To: T10 Technical Committee
 From: Rob Elliott, HP (elliott@hp.com)
 Date: 21 October 2002
 Subject: 02-360r2 SAS spinup

Suggested Changes

Create a new ENABLE SPINUP primitive. Immediately after power on, it is used to trigger automatic spin-up; afterwards, it interacts with the START STOP UNIT command to delay when software-requested spin-up actually occurs.

Figure 1 — SCSI application layer power condition (SA_PC) state machine

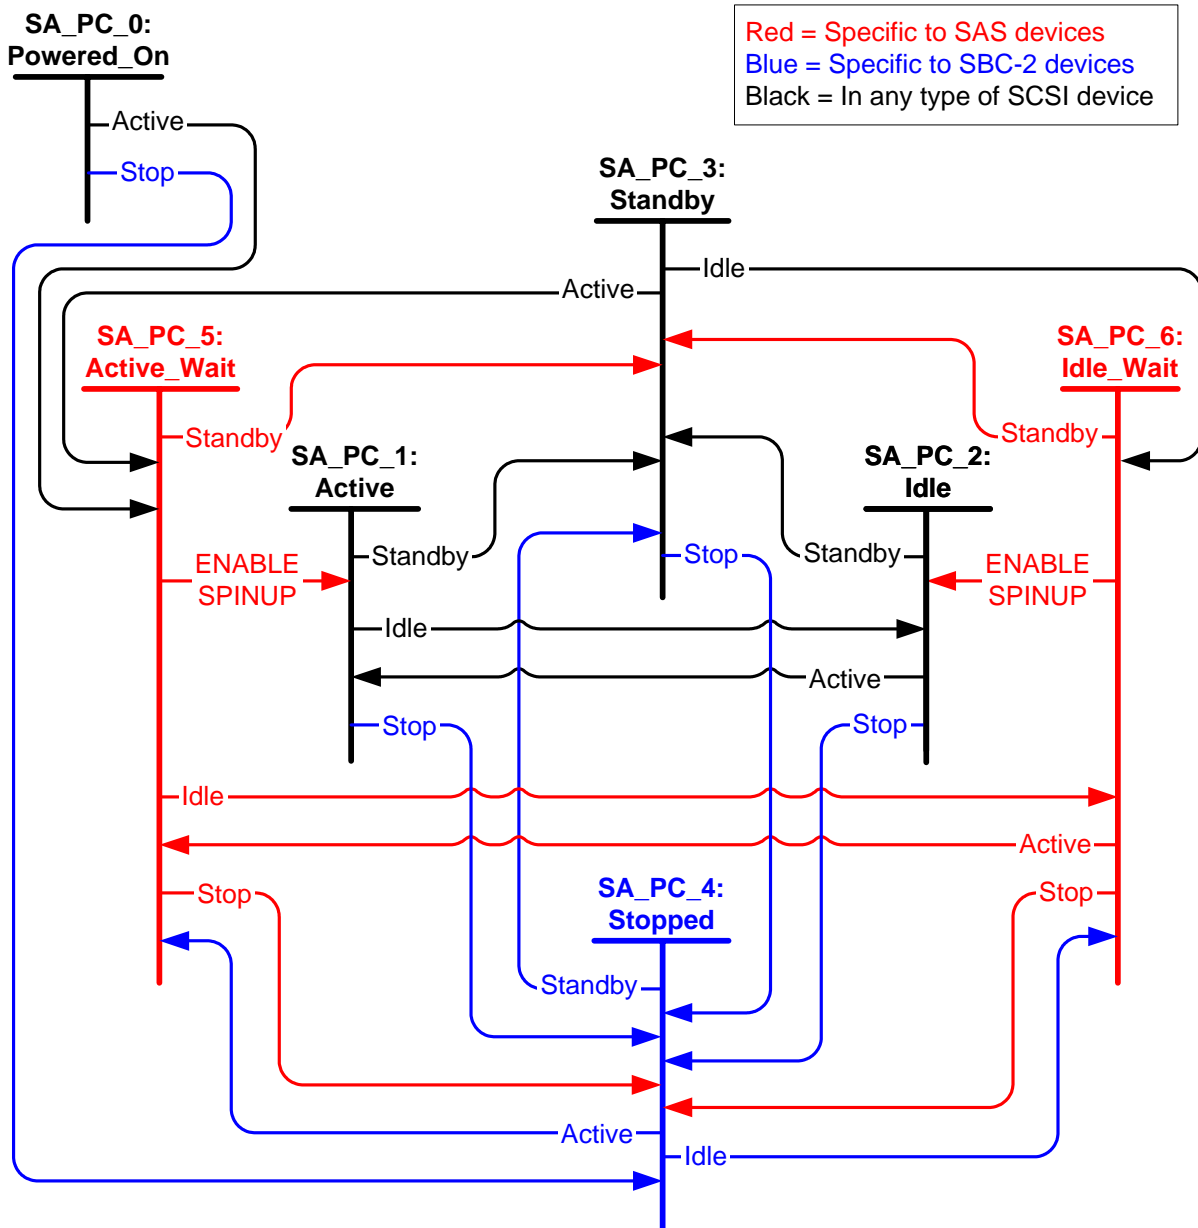
Revision 2 (21 October 2002) Rename SPINUP to ENABLE SPINUP. Allow devices without excessive power consumption in transitions to ignore ENABLE SPINUP. Added more arcs from Active_Wait and Idle_Wait since events can happen during those states; removed arcs from Powered_On that are now handled by Active_Wait.

Editor's Note 1: Editor's note: red and blue states and text are just for information in this proposal, and won't remain in the standard.

Figure 1 describes the SA_PC state machine.

The SCSI application layer Power Condition (SA_PC) state machine describes how the target device processes logical unit power condition state change requests and ENABLE SPINUP. The SA_PC state machine is an enhanced version of the logical unit power condition state machines described in SPC-3, SBC-2, and RBC. The SA_PC states are as follows:

- a) SA_PC_0:Powered_On;
- b) SA_PC_1:Active;
- c) SA_PC_2:Idle;
- d) SA_PC_3:Standby;
- e) SA_PC_4:Stopped (specific to SBC-2 and RBC devices);
- f) SA_PC_5:Active_Wait (specific to SAS devices); and
- g) SA_PC_6:Idle_Wait (specific to SAS devices);

The SA_PC state machine shall start in the SA_PC_0:Powered_On state after power on.
